BOSTON EDISON COMPANY
800 BOYLSTON STREET
BOSTON, MASSACHUSETTS 02199

BECO. Ltr. #82-90

Docket Number 50-293
License No. DPR-35

Additional Information on Block Walls

Figure 1

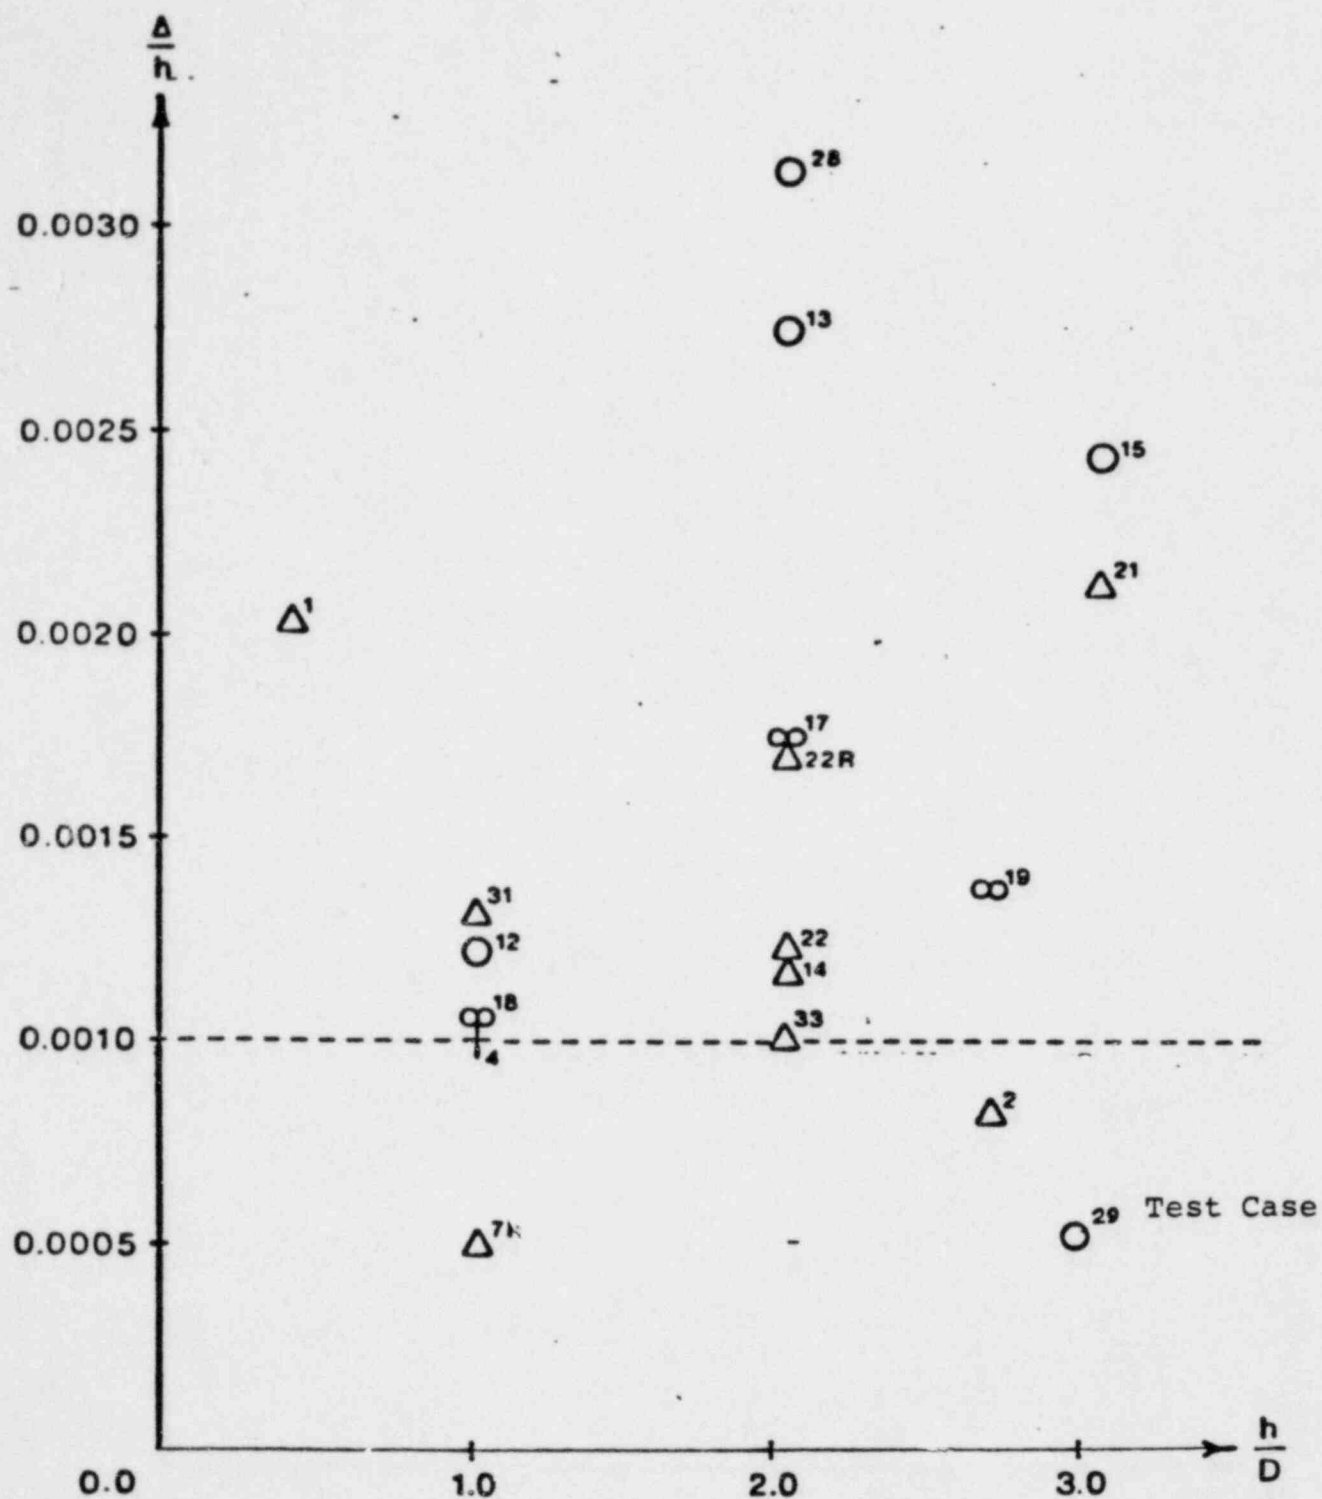
3. For the permissible strain of non-shear walls, the Licensee should provide the technical basis for using 0.1% and 0.01% for confined and unconfined walls, respectively.

The test program results were tabulated calculating the average shear stress, the shear distortion, and the wall height to width ratio.

The average shear stress, V/A , is determined from the first crack as tabulated in Table 5 of the test report. In some cases, the first crack may be a "moment crack" rather than a "shear crack". Generally the shear stress in the wall increases after the first moment crack.*

The test results of Δ/h vs. h/d were plotted in Figure 1 for four types of walls:
